City Council Staff Report

REQUEST
Consideration of a Resolution approving a Preliminary Plat application for Harmony Ridge Plat "A" subdivision consisting of 99 lots in the Planned Development (PD-3) zone

On May 23, 2023, plans were submitted for the Harmony Ridge Plat "A" subdivision consisting of 99 lots (69 townhome, 30 condos). The items below include 1) requested changes to the submitted plans, 2) other items required as part of the application and/or 3) informational items regarding city standards.

32' SECTION - PUBLIC
(WITH MODIFICATIONS)

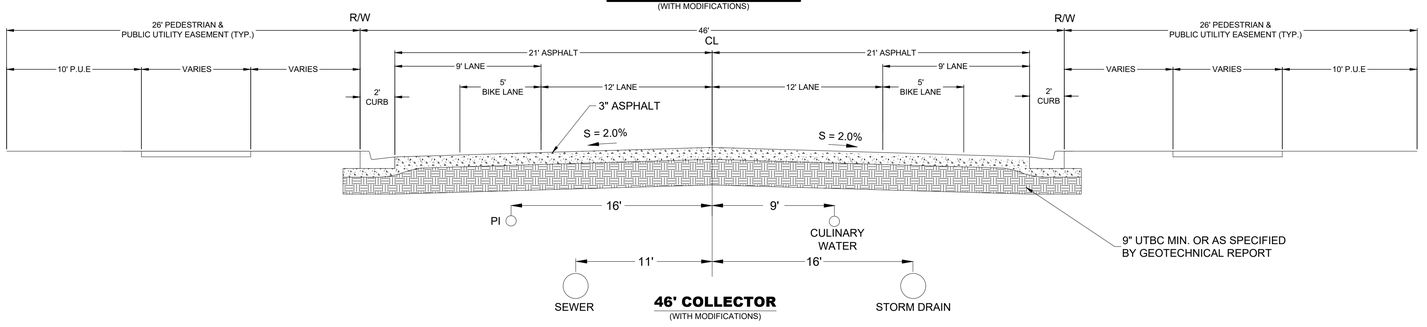
1. The 10' utility easements adjacent to the townhomes should be revised to reflect the 23' Pedestrian and Public Utility Easements as shown on the street cross sections (10' behind the sidewalk).
2. Update street names per the addresses provided by Community Development.
3. Call out sign locations or add the symbols to the legend.
4. Coordinate mailbox requirements with the post office and show locations on plans.
5. Fix overlapping callouts (for example, Sheet 407 plan view – water callout overlapping storm drain callout).
